URGENT Field Safety Notice

IntelliSpace Cardiovascular 6.x, 7.x, and 8.x

Report content may be inaccurate when using Finding Codes to add information

04-APR-2025

Screenshot 2

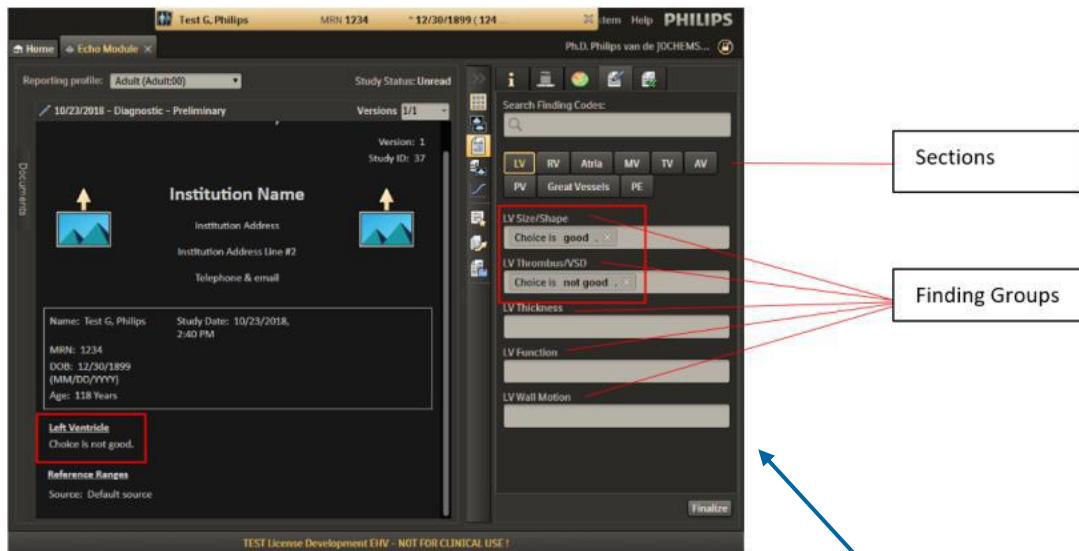
Screenshot 2, In the Echo Module add the same finding code (Choice is_) to the study (in work area interpret sheet), with different Qualifiers (good/not good) i.e. First add 'choice is good' to LV Size /Shape and then add 'choice is not good' to LV thrombus/VSD. Notice in the report (on the left-hand side) only the last added finding code_Qualifier i.e. 'Choice is not good' is added instead of displaying both the finding code_Qualifier ('Choice is good' and 'Choice is not good') from the finding groups. The issue is that the last entered finding code_Qualifier overwrites the previously entered finding code_Qualifier in the report. This is observed in all the sections (LV, RV, etc.).

Screenshot 3

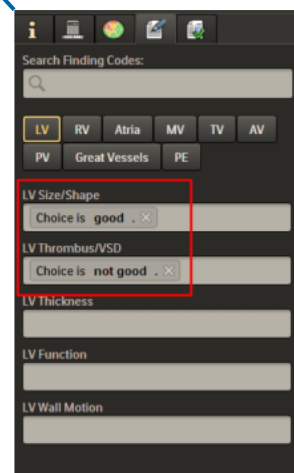
Screenshot 3: Double clicking a finding code_Qualifer, will insert the finding code_Qualifer into the 'Conclusions' section of the work area report sheet (on the left-hand side as shown in the Screenshot). A plus sign (+) is prefixed to the finding code_Qualifer in the finding group to indicate that the finding code_Qualifer has been successfully added into the 'Conclusion.' However, in this example while the finding code_Qualifer has a prefixed plus sign, but it does not appear in the 'Conclusions' section, this is because in this case, the last entered finding code_Qualifier (choice is not good) overwrites the previously entered finding code_Qualifier (Choice is good) in the report. This is observed in all the sections (LV, RV, etc.) however not in between sections (The finding code_Qualifier entered in LV section added to the conclusion will not be overwritten by the finding code_Qualifier that is entered in RV section even if it is entered last in the RV section).
